| Delegated Report | | Analysis sheet | | Expiry Date: | 02/06/2023 |
| Leela Muthoora | | | 2023/1876/P | | |
| 34 Meadowbank London NW3 3AY | | | See decision notice | | |
| Erection of an additional storey above existing roof level of dwellinghouse including rooflights and vents following removal of existing dormers. | | | | | |

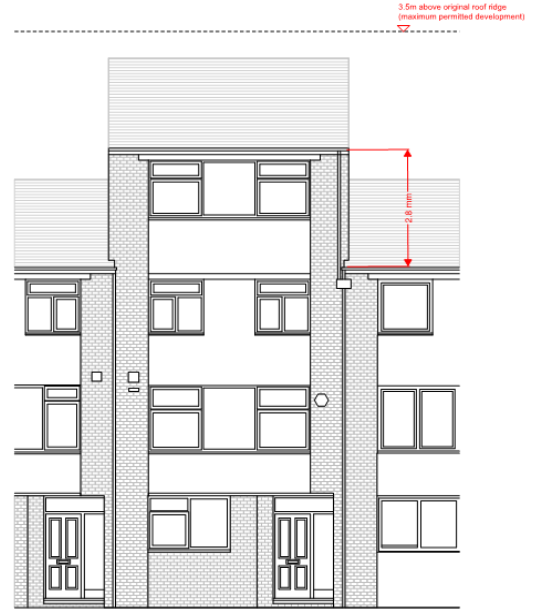
Furthermore, while several objections have pointed out this is the first site within the ‘central’ area of 3-storey houses to extend above the pitch roof, there are various roof additions across the estate. The prevailing heights of the perimeter buildings facing Ainger Road and Primrose Hill Road are four storeys consisting of ground floor and 1st to 3rd floors. There are many examples of full width dormers (roof additions) allowed under previous permitted development rules. This can be seen from the aerial view, facing south, below.

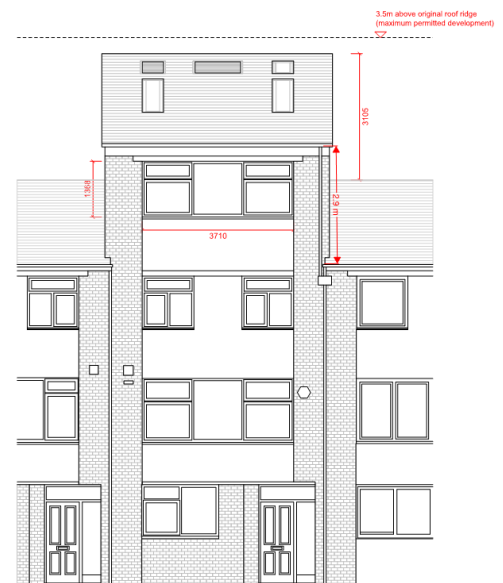
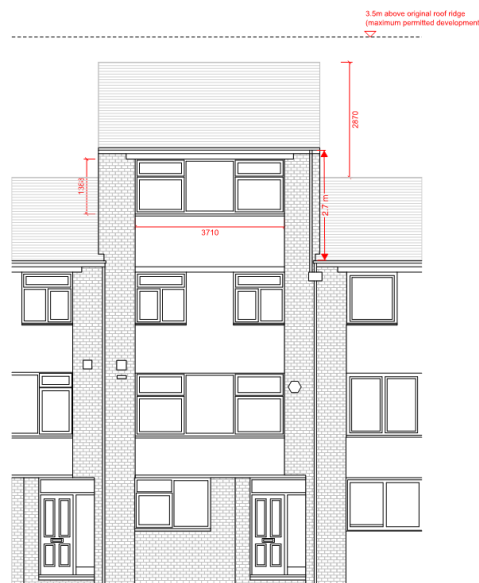
The existing roof additions (below left) extend 2.1m from the roof eaves to the roof ridge. The extant prior approval (below right) would be 2.8m from the roof eaves (an increase of 70cm from the existing) and the height of the roof would increase to 2.9m (which is within the 3.5m limit of the GPDO). The pitched roof is a requirement of the GPDO.

The proposal under consideration (below right) would be 2.9m at the roof eaves, an increase of 10cm above extant approval (below left) and 80cm increase above existing roof eaves. The height of the roof would be pitched to the roof ridge and would increase to 3.1m, an increase of 20.5cm above extant approval (also within the 3.5m limit of the GPDO).

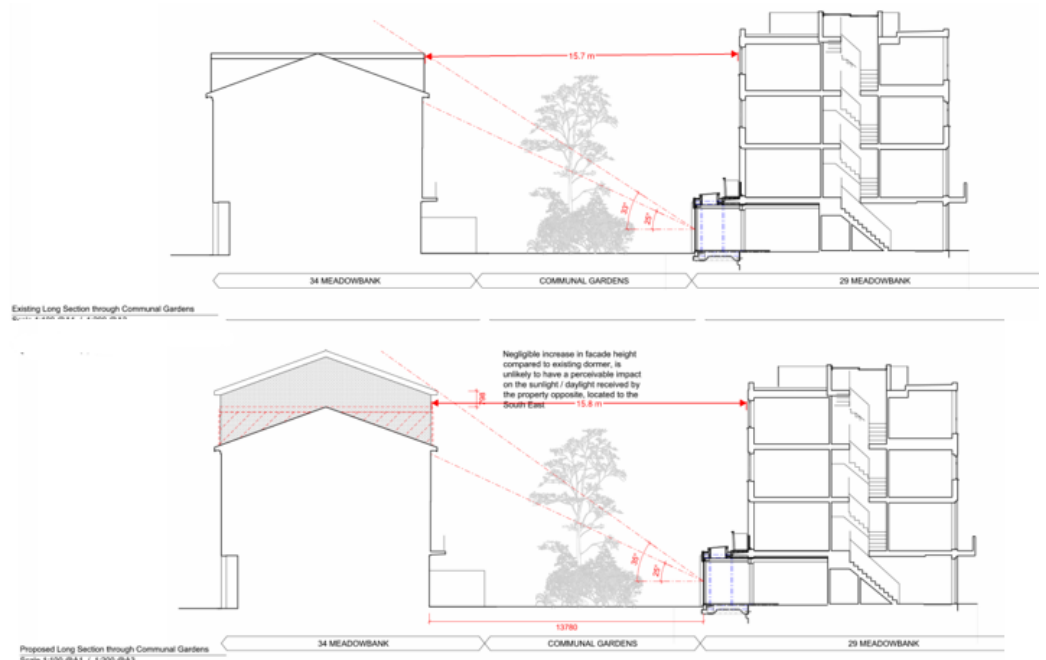
The impact of the additional storey on the neighbouring homes and communal garden has been assessed in the Daylight Sunlight Assessment. Windows south of the proposed development have been assessed and meets the Building Research Establishment (BRE) guidance. The impacts on the communal garden which would be overshadowed would be small. The proposal would not have a significant effect on the daylight and sunlight levels received by neighbouring properties. See paragraph 2.6 in the assessment.

To the rear, the additional storey meets the 25-degree rule, as shown in drawing number PD3230 and below. We can only assess the application as it is, any subsequent application would be assessed on its own merits.
